CITY OF ALBUQUERQUE

July 27, 2023

Re: Mata Auto Garage
142 40th St. SW
Traffic Circulation Layout
Architect's Stamp 03-03-23 (K12-D037)

DRAINAGE AND TRANSPORTATION INFORMATION SHEET (REV 6/2018)

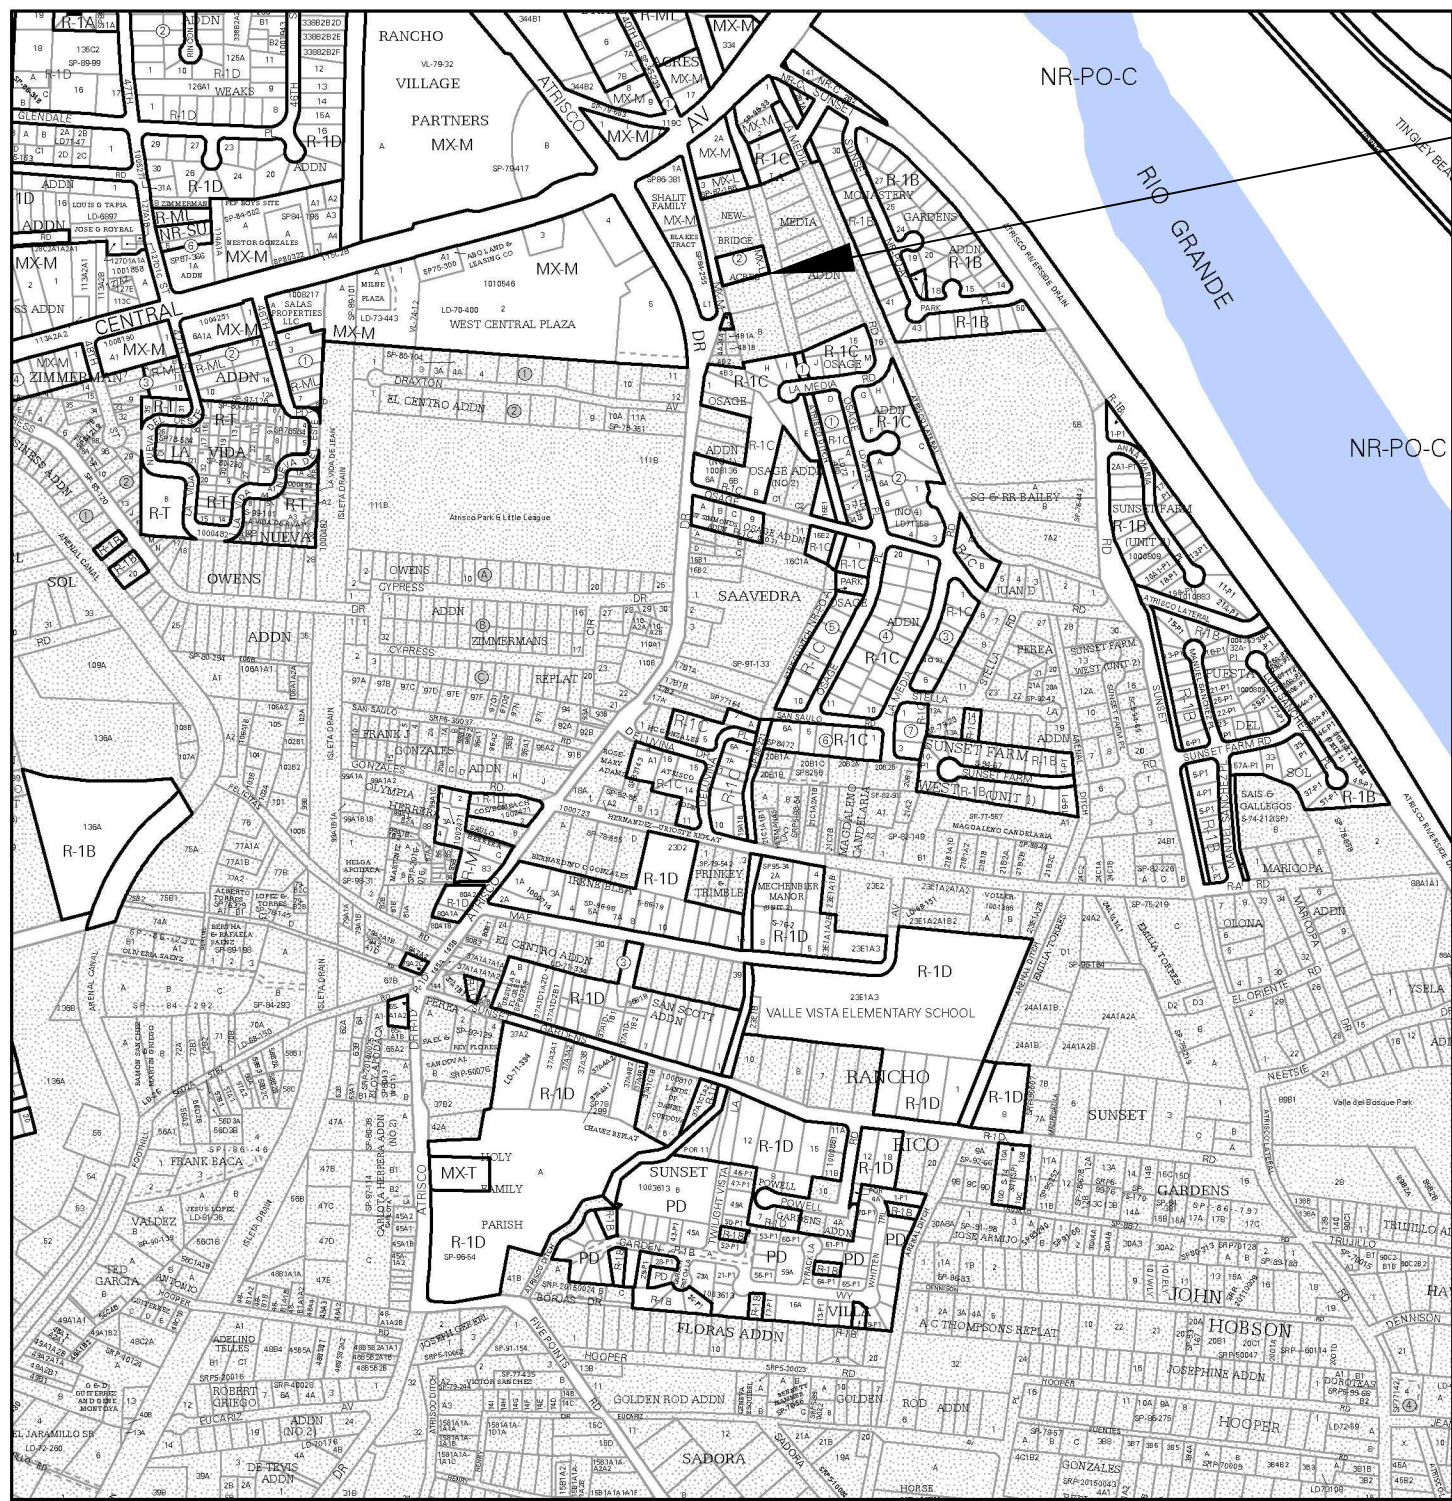
1. List the number of Bicycle and Motorcycle parking spaces required by the IDO.
2. Identify all existing access easements and rights of way width dimensions.

3. Identify the right of way width, medians, curb cuts, and street widths on 40TH St.
4. Show on the site plan site access's width and provide driveway design details.

5. Keynote 7: please reference COA std dwg 2430 for the proposed sidewalk.
6. Please show on the site plan the width for the proposed parking spaces. Minimum standard and ADA stall parking width is 8.5 ft.

7. Sheet TCL-2 is missing.
8. The ADA accessible parking sign must have the required language per 66-7-352.4C NMSA 1978 **"Violators Are Subject to a Fine and/or Towing."** Please call out detail and location of signs.

9. Motorcycle parking spaces shall be designated by its own conspicuously posted upright sign, either free-standing or wall mounted per the zoning code.

10. The pavement marking "MC" should be shown in the opposite direction for motorcycles entering the parking space.
11. Per the IDO, a 6 ft. wide ADA accessible pedestrian pathway is required from the public sidewalk to the building entrances. Please clearly show this pathway and provide details.

12. Per DPM, a 6 ft. wide ADA accessible pedestrian pathway is required from the ADA parking stall access aisles to the building entrances. Please clearly show this pathway and provide details.

13. ADA accessible pedestrian pathway should not be placed behind parking space or adjacent to a vehicular way. Vehicle and pedestrian/wheel chair conflicts should be avoided as much as possible.

14. All sidewalks along streets should be placed at the property line.

15. Curbing should be installed to delineate landscape, parking, and pedestrian ways and identify points of access. Please call out detail and location of barrier curb.

16. Refuse vehicle maneuvering shall be contained on-site. The refuse vehicle shall not back into the public right of way.; provide a copy of refuse approval.
